Town of Duanesburg
Planning Board Agenda
October 19, 2023

**Re: Town of Duanesburg
Wishy Wash Site Plan & Special Use Permit Review
Amendment #3 for Engineering Services**

In response to the new comments (*in italics*), (previous comments unaltered font) of Doug Cole of Prime AE of April 12, 2023, we respond as follows (**in bold**):

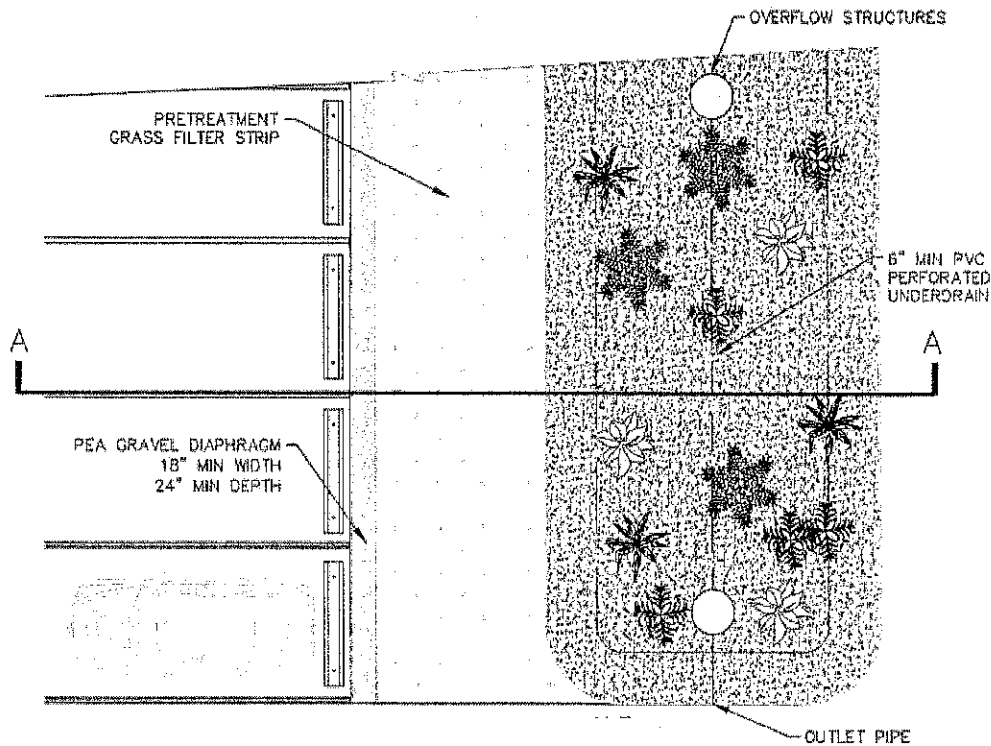
2. The proposed bioretention practice shows a 6" underdrain pipe to daylight discharging to the south of the facility onto lands of the applicant and a 12" HDPE outlet pipe and emergency spillway from the facility are shown exiting to the east onto lands of Thomas into an existing drainage swale which then flows through lands of Chilton prior to joining a stream that flows under NYS Route 20 near Gage Road. We have learned that a similar gravel parking area project was reviewed and approved by the Planning Board last year with a different stormwater design that kept all stormwater discharges on site, however, the design was not constructed as approved and the Town Permit was rescinded. In the December 15, 2021 letter to Dale Warner from Brett Steenburgh, P.E. regarding neighbor property flooding due to prior work performed on the gravel parking area, we located a statement attributed to Jamie Malcolm, NYSDEC Region 4 which said he "suggested that they maintain the existing drainage pattern and drain the pad to the southeast corner and not try to create the swale towards the car wash driveway and down US Route 20 ... as it may cause problems within the highway drainage system and inundate the existing culverts under the driveways of Wren and Chilton." We have not verified this statement with Mr. Malcolm, however, it is in keeping with NYSDEC requirements that the project design must ensure that there is no increase in runoff from a new development project and that there are no adverse effects downstream of the project. We understand that a bioretention practice has

been designed to mitigate the offsite impacts of this project, however, since there are known issues with the current drainage pattern, we ask that the applicant provide additional information why the original plan to keep discharges on site are not practical if proper stormwater management practices are put into place to mitigate effects on the Route 20 drainage system and neighboring driveway culverts. Please also refer to our further comments on the stormwater design in the Drainage Narrative section of this letter. **We have read the response to this comment in the 10/7/22 response letter from ABD, which did not answer the question above. Additionally, there are still concerns as noted below:**

- a. There needs to be test pit data that shows the proposed bottom of the Bioretention practice will be at least 2 feet above the high groundwater table. There is a note on the detail for the practice about using a poly-liner if the separation cannot be met, but this should be known at this point in the process. **The applicant has stated that groundwater is expected 18" below the surface and that is why a poly-liner has been selected. We accept this response.**

- b. Review of the Stormwater Design Manual (SWDM) shows that Bioretention is an acceptable practice for water quality treatment but is not to be used for water quantity control. An appropriate quantity control practice needs to be included for this project. **Please refer to comment 5.e under SWPPP section.**

Figure K.5 On-Line Versus Off-Line Schematic

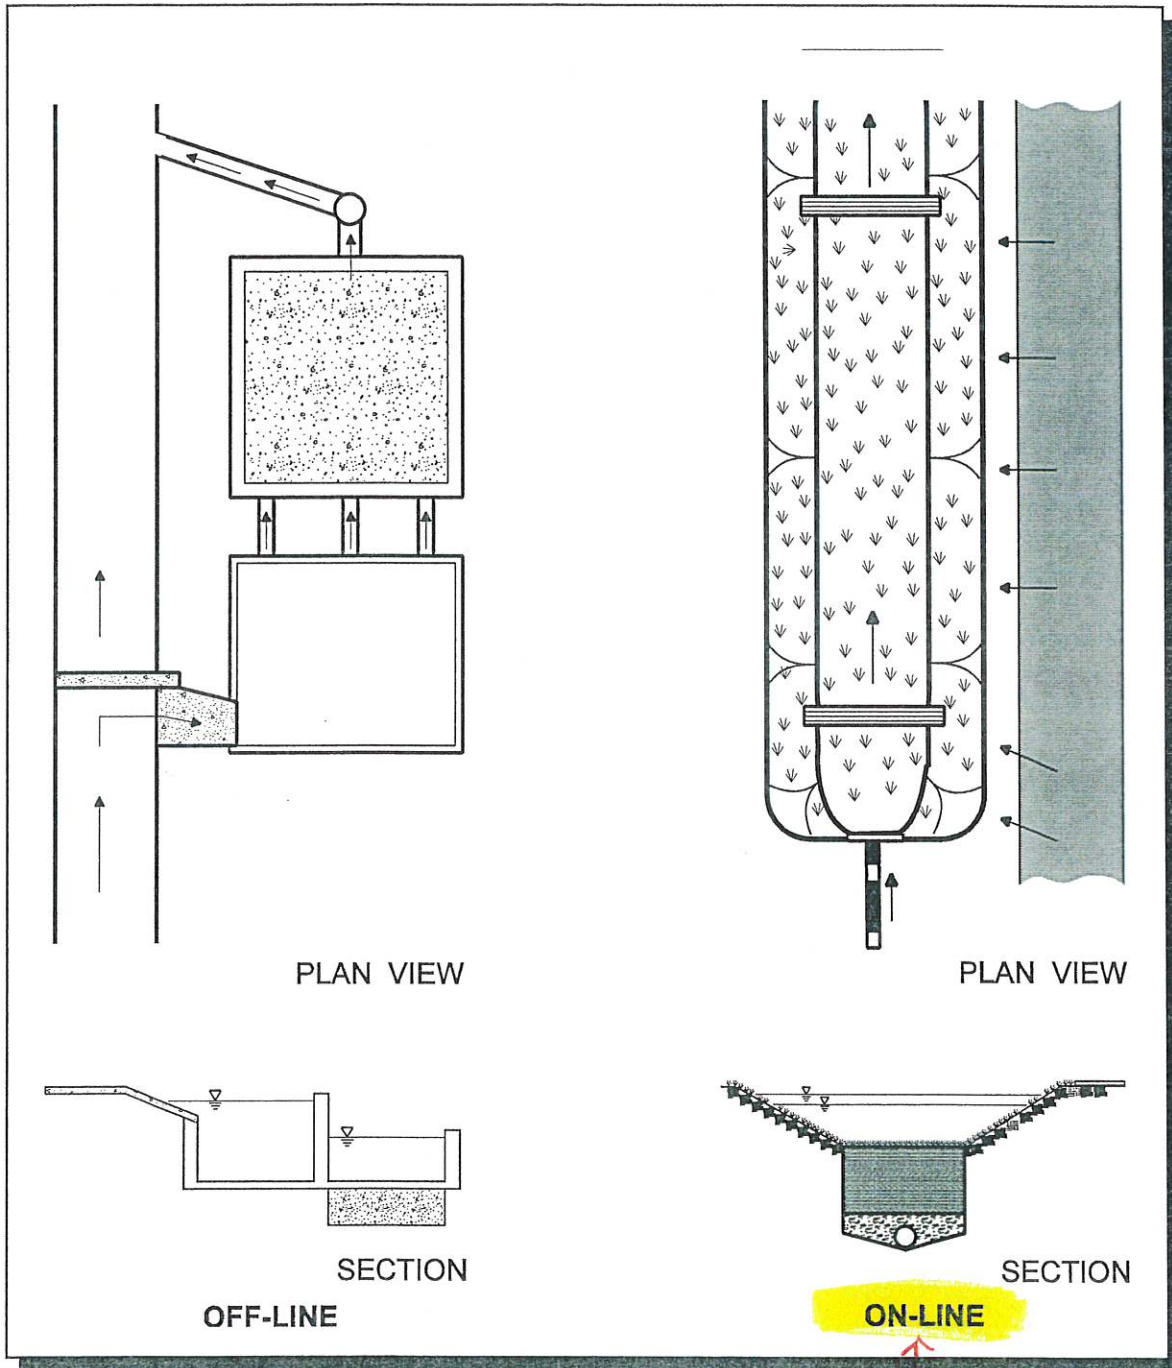
System being proposed
